# Staff Feedback on NuScale's Response to RAI 9666 Related to the EPZ Sizing Methodology Topical Report (TR-0915-17772)

Public Meeting

August 6, 2019

# Crane Fragility

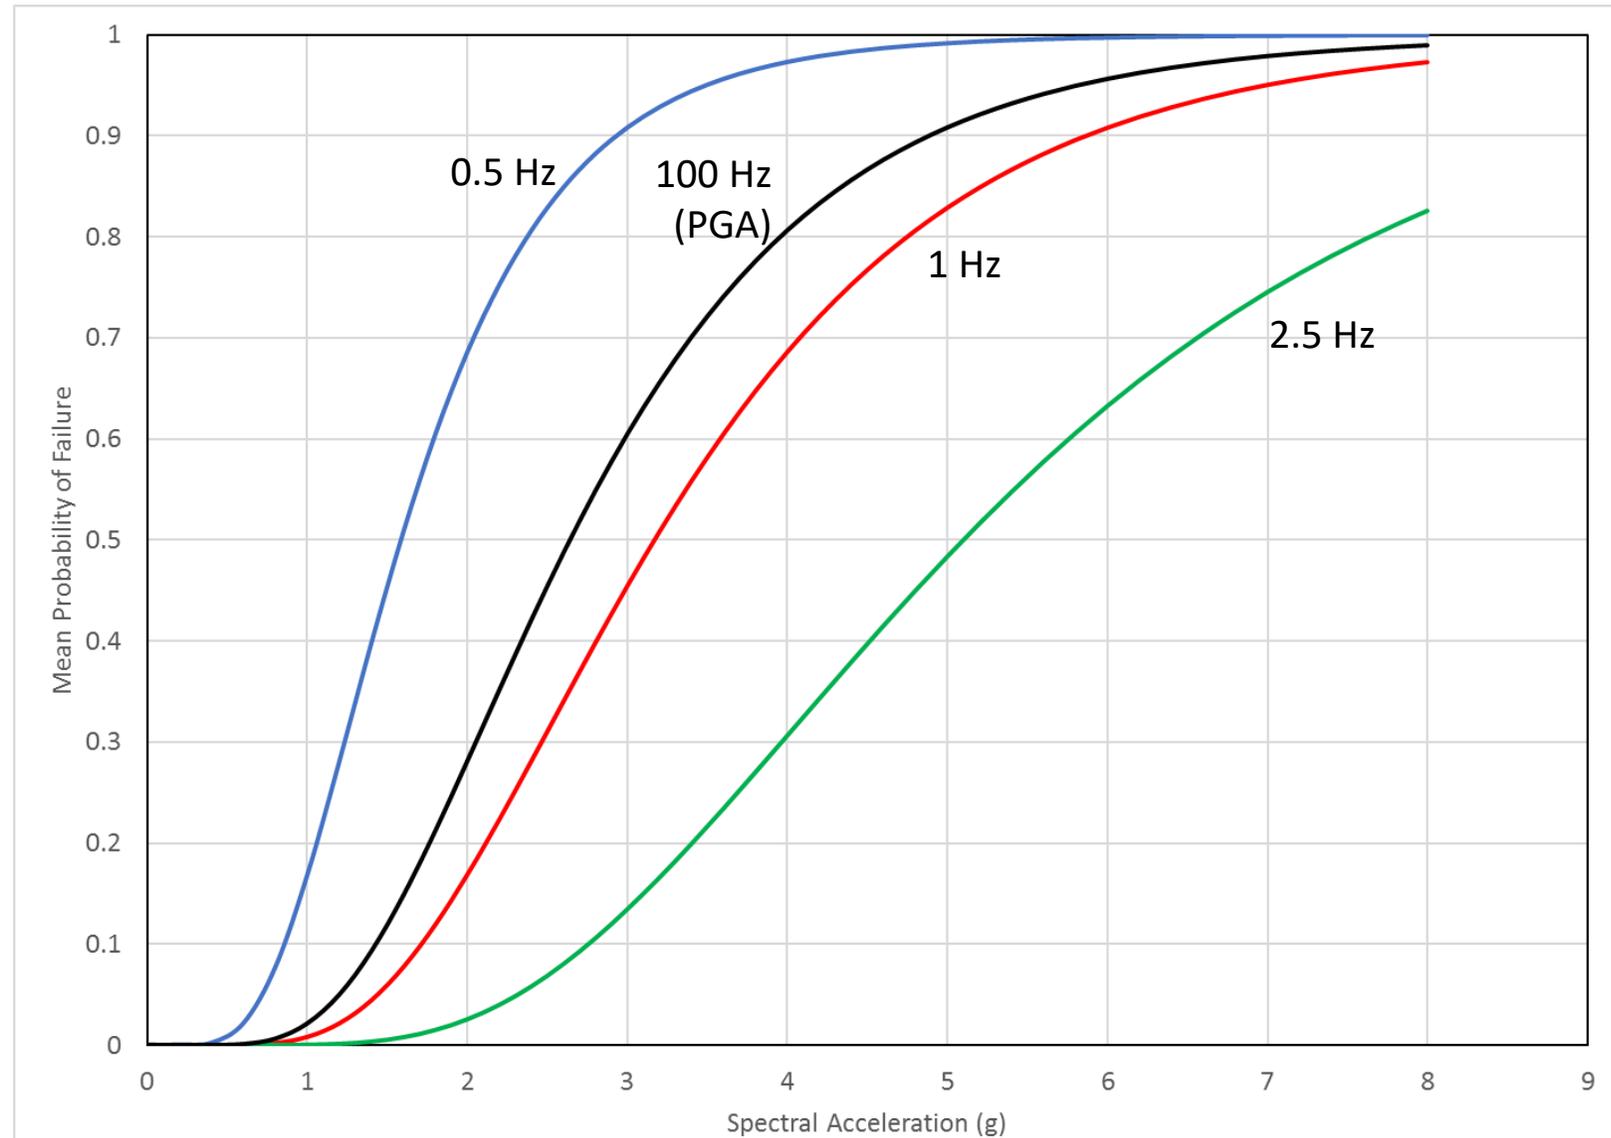
- NuScale Crane HCLPF “High Confidence Low Probability of Failure”
  - HCLPF=0.88 g
  - Uncertainties
    - $\beta_u=0.39$
    - $\beta_r=0.28$
- HCLPF value is for PGA or 100 Hz ground motions
- The natural or resonance frequency for large structural SSCs ranges from about 0.5 to 2.5 Hz
- Convert PGA HCLPF to HCLPF for 0.5, 1, and 2.5 Hz
